*Third Preliminary Consultation*  
**MONTGOMERY COUNTY HISTORIC PRESERVATION COMMISSION**  
**STAFF REPORT**

<b>Address:</b>	4721 Essex Ave., Chevy Chase	<b>Meeting Date:</b>	6/14/2017
<b>Resource:</b>	<b>Primary (Pre-1915) Resource</b> (Somerset Historic District)	<b>Report Date:</b>	6/7/2017
<b>Applicant:</b>	Richard and Michelle Scurfield	<b>Public Notice:</b>	5/31/2017
		<b>Tax Credit:</b>	N/A
<b>Review:</b>	3 <sup>rd</sup> Preliminary Consultation	<b>Staff:</b>	Michael Kyne
<b>Case Number:</b>	N/A

**PROPOSAL:** Rear addition, garage, hardscape, and tree removal

Right Elevation - Proposed  
3/32" = 1'-0"

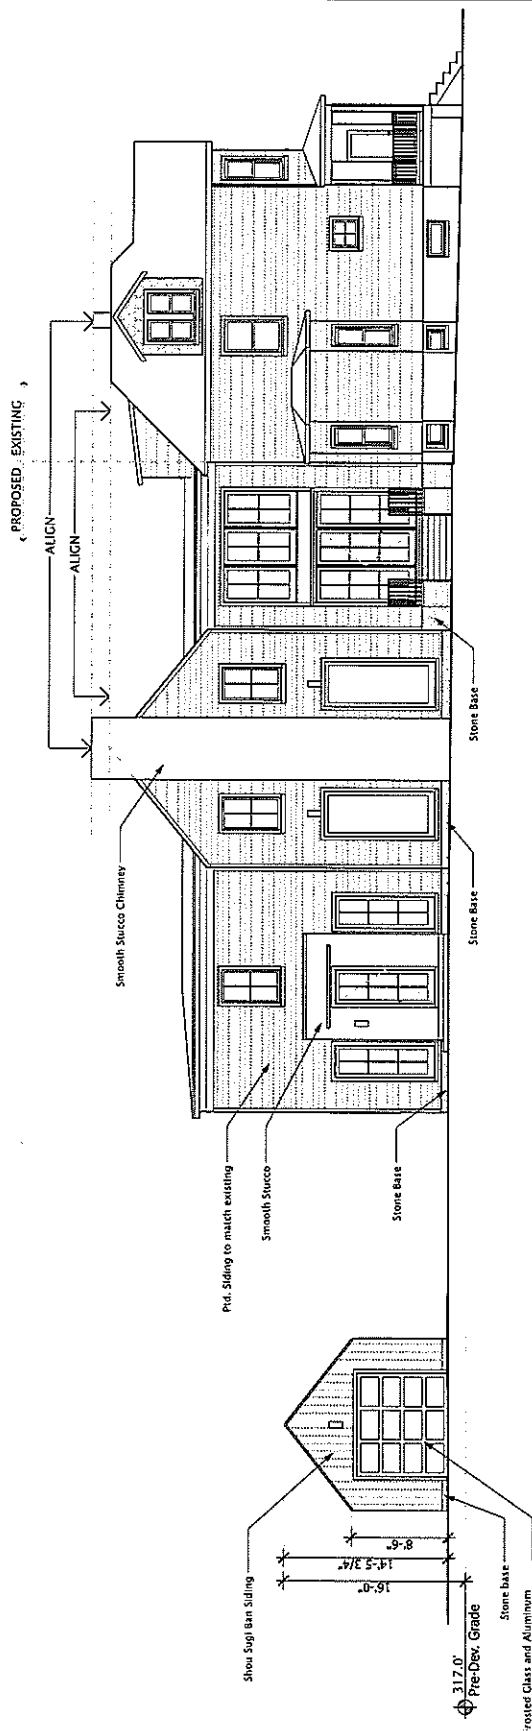
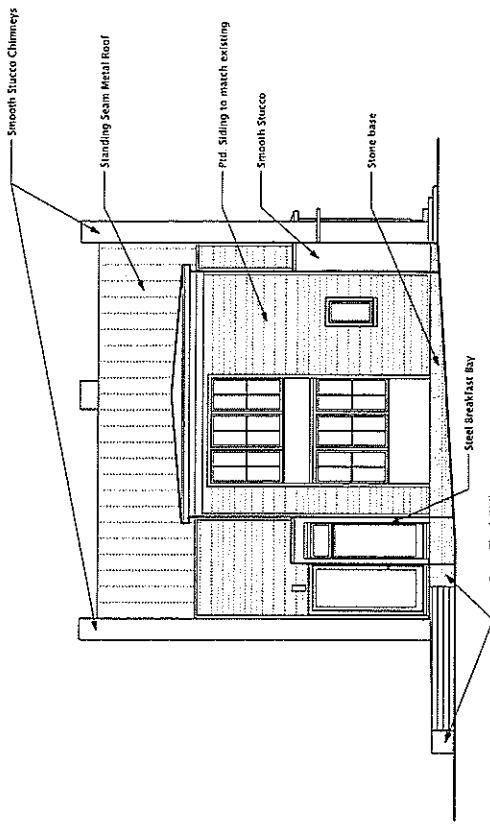
Staff finds that the proposed revisions have reduced the perceived scale and massing of the proposed additions, diminishing the potential for the scale and massing to detract from the historic district. Staff asks the Commission to provide any guidance that would further minimize the visual impact of the proposed additions.

T12.  
28" Poplar proposed to be removed  
to accommodate new house  
foundation and overdig.

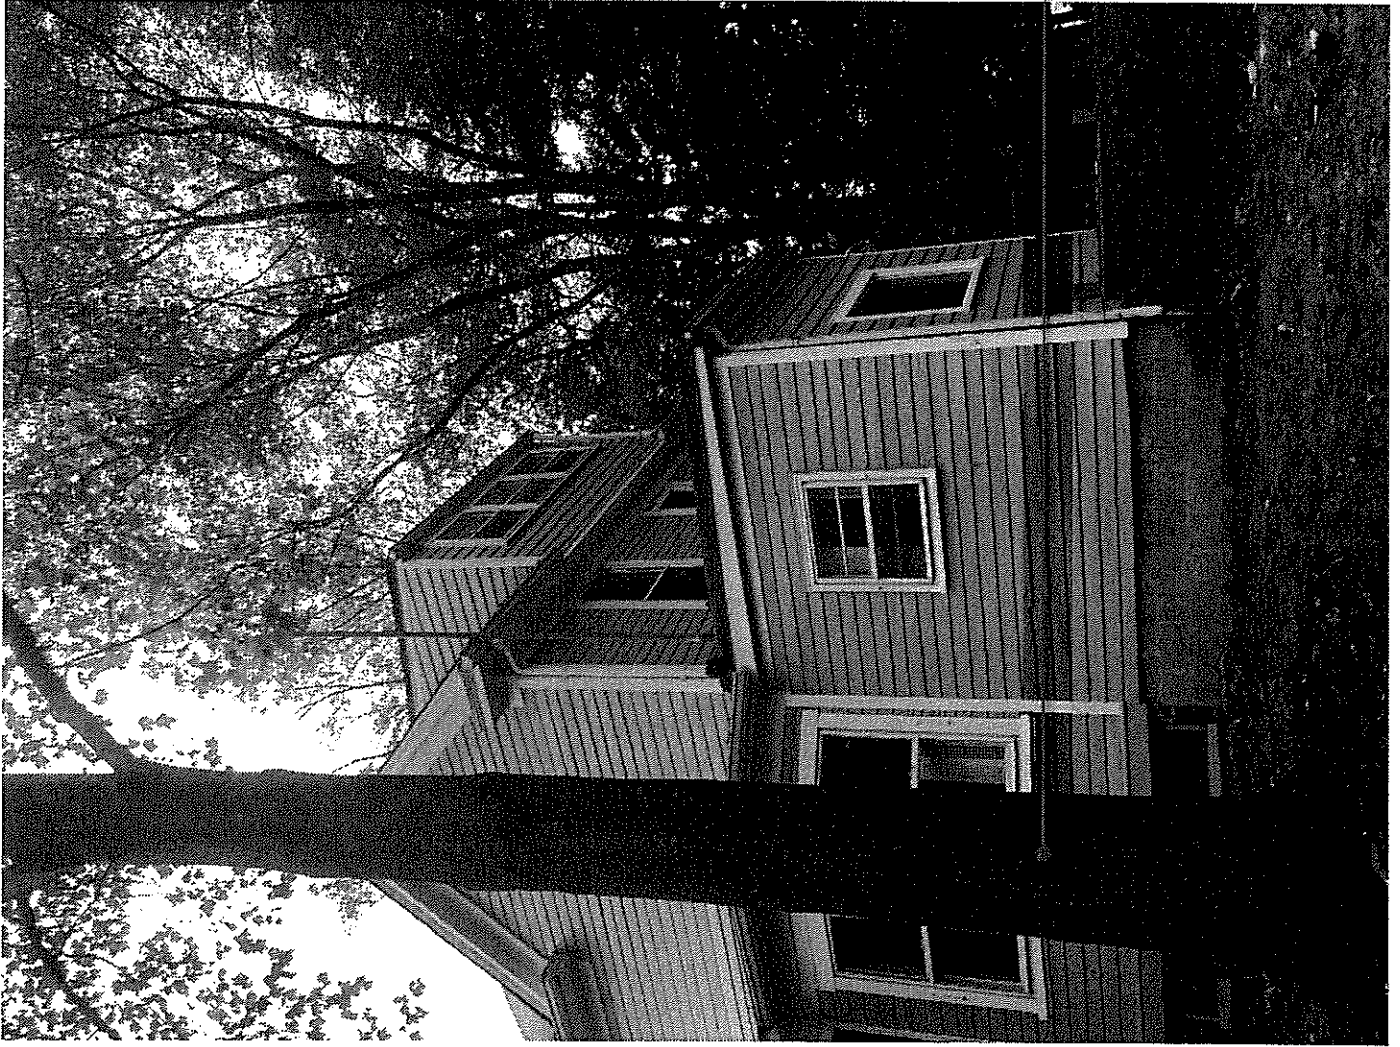
The applicant proposes to remove five (5) mature trees to accommodate the construction of the proposed garage, turnarounds, and additions. A row of 22 hemlock trees is also proposed to be removed from the front of the property (adjacent to the sidewalk). The applicant has provided a plan to replace some of the trees that will be removed (see Circle 10). Given the importance of mature trees in the Somerset Historic District (see *Guidelines*), staff asks for the Commission's guidance regarding the proposed tree removals.
